U.S. Department of Energy
Attention: Comments--EA
1000 Independence Avenue, SW
Washington, DC 20585

SEARCH. technical services
(509) 725-6666
STAR ROUTE BOX 17, DAVENPORT WA 99122

REFERENCE: Technical Review Comment on
DRAFT EA: REFERENCE REPOSITORY LOCATION,
HANFORD SITE, WASHINGTON, December 1984.

FIGURE 1.

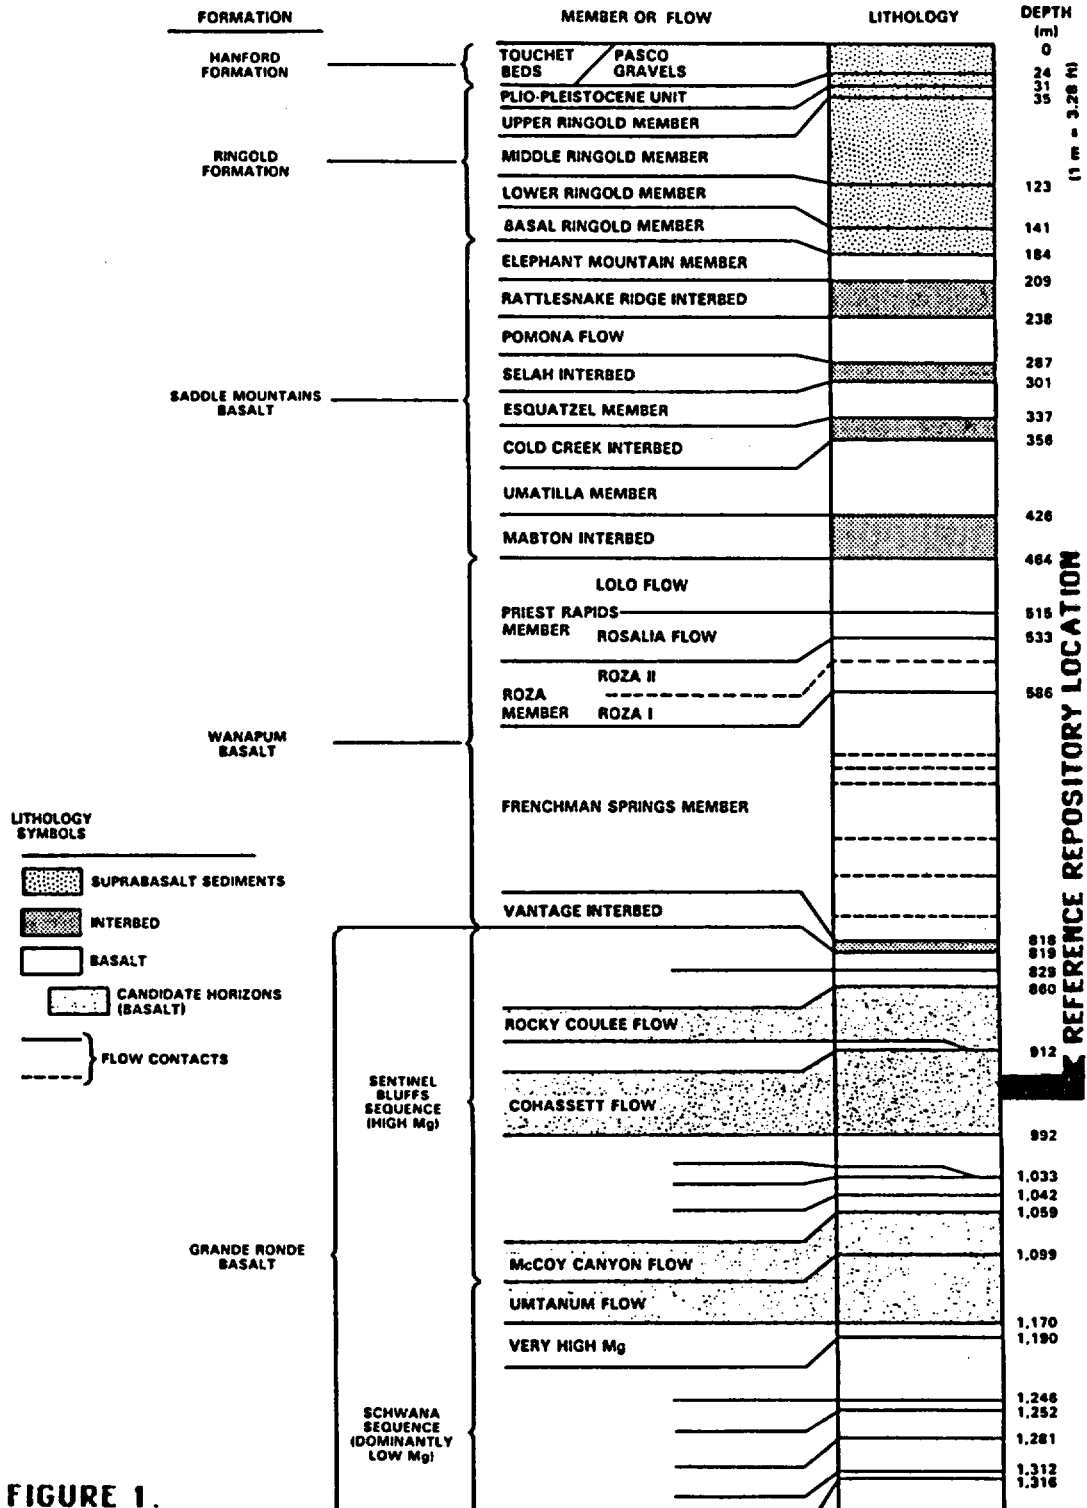
This review assumes that the repository is emplaced within the Cohasset Flow of basalt at a depth of about 3,000 feet, Fig. 1 [2]. This review further represents that accessible environment to be the Columbia River which is about 60,000 feet to the east of the reference repository location, Fig. 2 [3]. Corresponding to these vertical and horizontal scales, any significant pathway

Begin with the observation that ground-water travels quite rapidly, horizontally, in sedimentary units such as the surface aquifer at Hanford. Thus, the stratigraphy of Fig. 1 may be reexamined for a sedimentary "interbed" which might have hydraulic conductivity similar to the surface aquifer but would not require such a lengthy vertical leg between the reference repository and that interbed.

FIGURE 3.

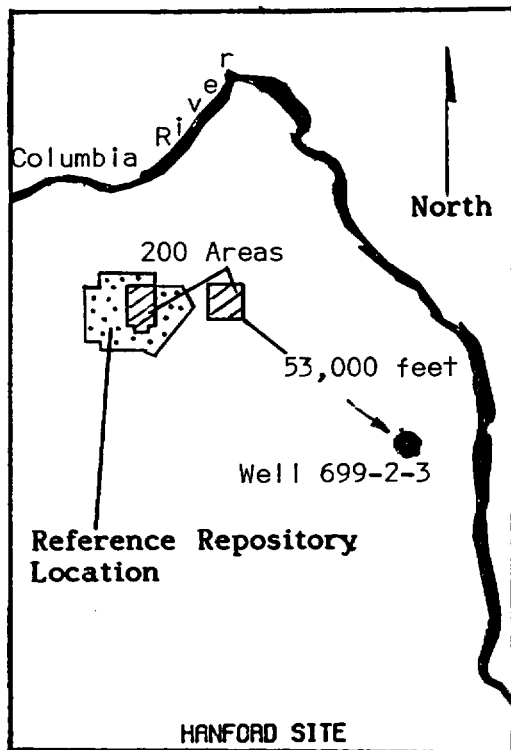
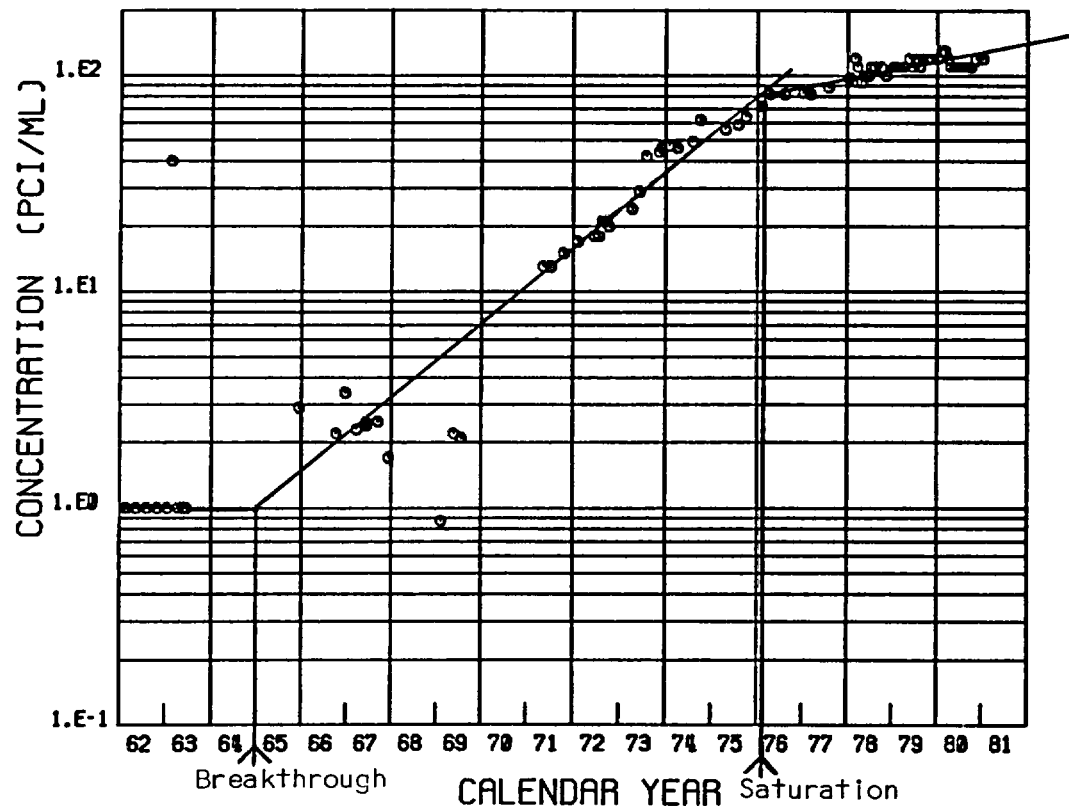
To obtain a rough idea of expected horizontal ground-water travel times in the area, one may examine the tritium plume released (beginning in 1944 or later) from the 200 East Area which lies just east of the reference repository location. The surface aquifer plume from the 200 East Area reached Well 699-2-3 in

Fig. 3 [4]. The site map in Fig. 3 shows that Well 699-2-3 is about as far east of the 200 East Area as the Columbia River is east of the reference repository location. That is, this 21-year period is a crude estimate of the travel time which might be expected for the horizontal leg of a sedimentary pathway connecting the repository to the Columbia River.

Well 699-2-3 was selected for this travel time estimate because its tritium record is particularly simple: There is an abrupt breakthrough of tritium-bearing water in 1965, followed by an exponential increase in concentration, followed by near attainment of saturation concentration in 1976.

Breakthrough, however, does not imply a significant release of radionuclides to the Columbia River. As Fig. 3 shows, the breakthrough concentration of radionuclides is negligible: The maximum concentration of radionuclides released to the Columbia River requires about 50% more time. That is, the expected travel time for significant radionuclide travel to the Columbia River is

FIGURE 4.

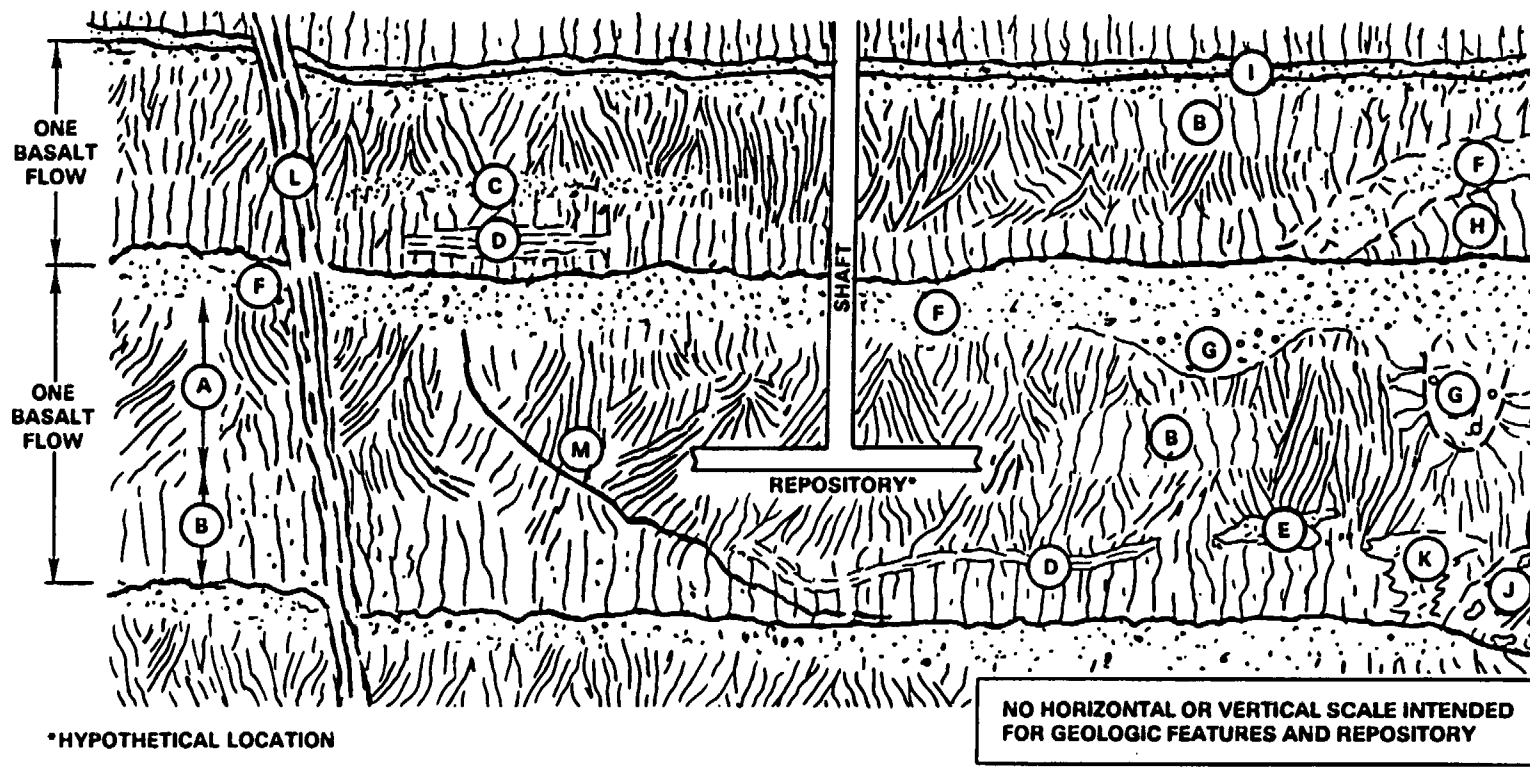
Figure 4, taken from the DEA, provides a hypothetical, composite cross section of possible geologic features in a layered basalt sequence with the repository sketched [4]. This figure shows an interbed situated one basalt flow above the basalt flow in which the repository is located. Furthermore, Fig. 4 shows a major fault or fracture which connects the level of the repository with the level of the interbed. That is, Fig. 4 presents hypothetical vertical and horizontal legs of a pathway which might connect the repository to the Columbia River.

FIGURE 5.

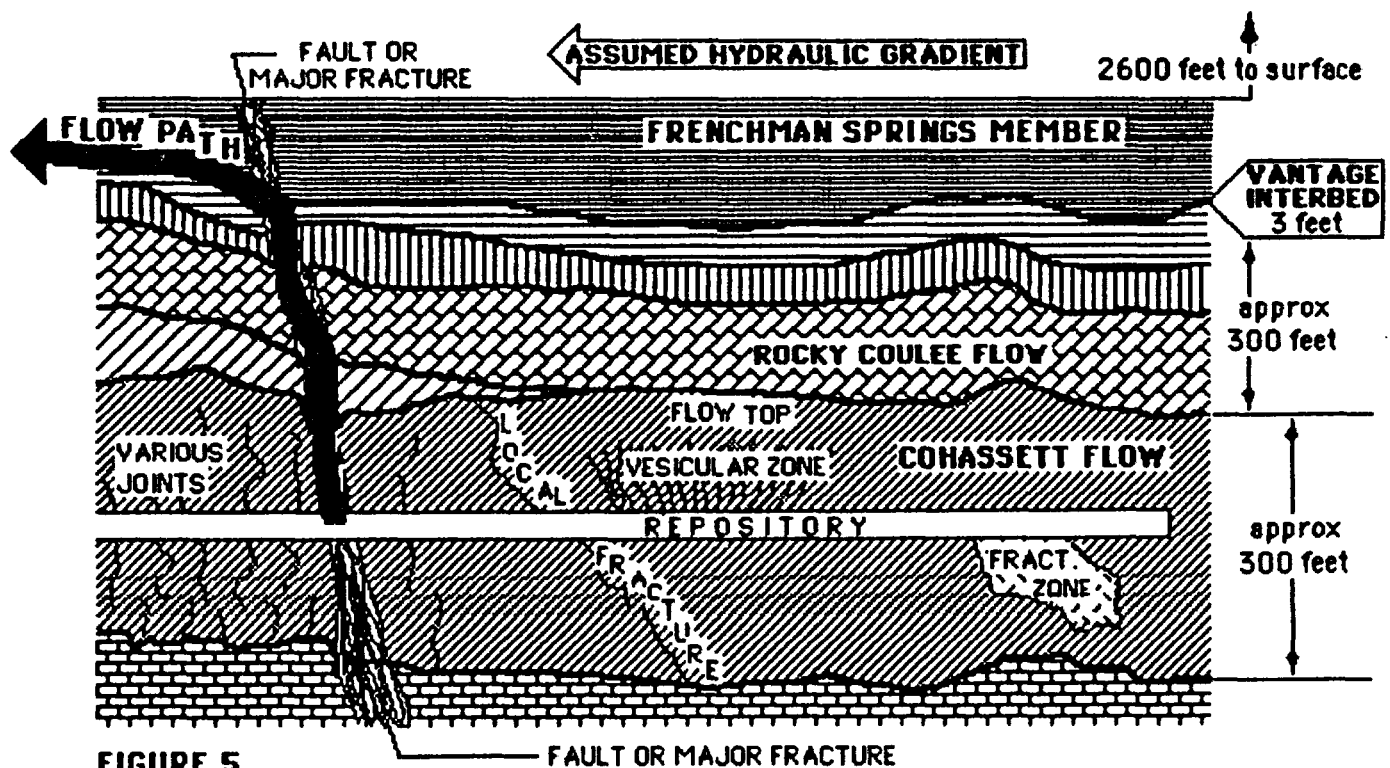
stratigraphy (Fig. 1) may be combined with the hypothetical geologic features of Fig. 4 to allow some appreciation of possible spatial relationships. Figure 5 is the diagrammatic result, with the repository shown in the Cohasset Flow which the DEA finds to be most geologically promising [6].

The striking feature of this scaling of the actual structures is the great horizontal extent—about 11,000 feet [7]—of the repository.

Figure 5 shows this scaled repository to cross several vertical discontinuities in the Cohasset Flow. The most severe of these discontinuities, a fault or major fracture, is shown as connecting the repository to the Vantage Interbed, some 400 feet above it.

The next step is to estimate how likely it is that the 120,000,000 square-foot repository will actually intersect such a fault or major fracture. Three lines of inquiry suggest that such intersection is very likely: (1) One major discontinuity, the "Cold Creek Barrier," is already identified next to the reference repository location, in DEA Fig. 3-1. (2) General descriptions of Central Basin basalt outcropping [8] and easily made observations from roadways reveal major vertical discontinuities with horizontal scales much less than the repository scale. (3) General consideration of quasi-static plate failures suggests fracture spacing on the order of plate thickness, in this case less than 1,000 feet. On this basis, an arrow is drawn into Fig. 5 to depict the probable, significant flow pathway for the reference repository location in the Cohasset Flow.
